Technical Service Bulletin

87 Faint noise heard in cabin from air conditioning circuit

87 17 82 2044717/5 September 20, 2017. Supersedes Technical Service Bulletin Group 87 number 17-81 dated August 16, 2017 for reasons listed below.

Model(s)	Year	VIN Range	Vehicle-Specific Equipment
A6, A7	2012 - 2015	All	2.0L or 3.0L gas engine

Figure 4. Low side line to be replaced.

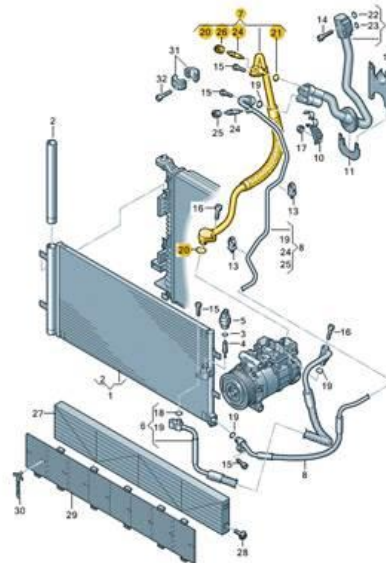
3. Replace the low side refrigerant line that connects the air conditioning compressor suction port to the hybrid refrigerant line to the expansion valve (Figure 4). Be certain to use new O-rings at these and all refrigerant circuit joints that are disconnected.

Figure 5. Balance weight position on low side line.

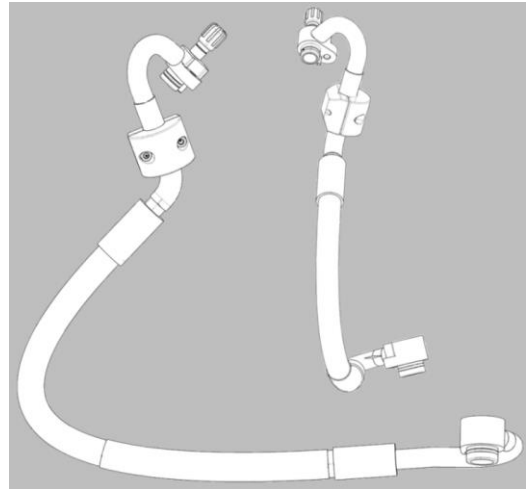
4. Install the balance weight (part number 4G0513621A) to the line in the position shown in the illustration (Figure 5).
